Access Compliance Report Public Rights-of-Way (Curb Ramps)

Intersection ID: 52915	Main Street: WILLOW_GREEN_PL	Cross Street: WOODWARD_AV	Location: NE
ADA ID: C18D2E211A8D	Ramp Type: Directional1	Initial Pass/Fail: Fail	Overall Compliance: No Severity Score: 12.5

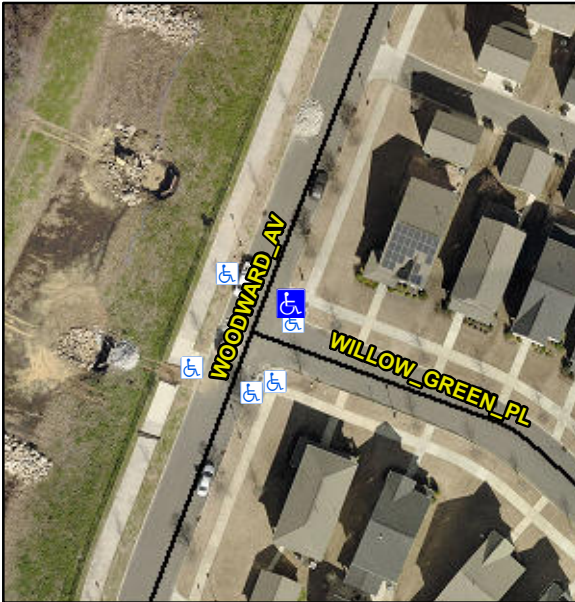
R304.2.2

Compliance	Description	Data	Compliance	Description	Data
N/A	Ramp Length (in)	66.0	N/A	Grade Break?	N/A
Yes	Ramp Width (in)	59.0	N/A	Grade Break Slope (%)	0.0
No	Ramp Slope (%)	10.4	N/A	Grade Break XSlope (%)	0.0
Yes	Ramp XSlope (%)	1.1			
N/A	Flare Type LT	N/A	N/A	Flare Type RT	N/A
N/A	Flare Slope LT (%)	N/A	N/A	Flare Slope RT (%)	0.0
N/A	Flare Traversable LT?	N/A	N/A	Flare Traversable RT?	N/A
N/A	Landing Length (in)	0.0	N/A	DWS Provided?	N/A
N/A	Landing Width (in)	0.0	N/A	DWS Contrast?	N/A
N/A	Landing Slope (%)	0.0	N/A	DWS Length (in)	N/A
N/A	Landing X Slope (%)	0.0	N/A	DWS Full Width?	N/A
N/A	Landing Curb? (Y/N)	N/A	N/A	DWS Offset LT (in)	N/A
N/A	Shared Landing?	N/A	N/A	DWS Offset RT (in)	N/A
N/A	Gutter Ponding?	0.0	N/A	Gutter Slope (%)	N/A
N/A	Gutter Lip Ht (in)	0.0	N/A	Gutter X Slope (%)	N/A
N/A	Painted X Walk1?	No		Road Slope (%)	4.0
	X Walk 1 Direction	To W		Road X Slope (%)	1.3
	X Walk 1 Width (in)	N/A		Clear Space?	N/A

Remove & Replace Entire Ramp.
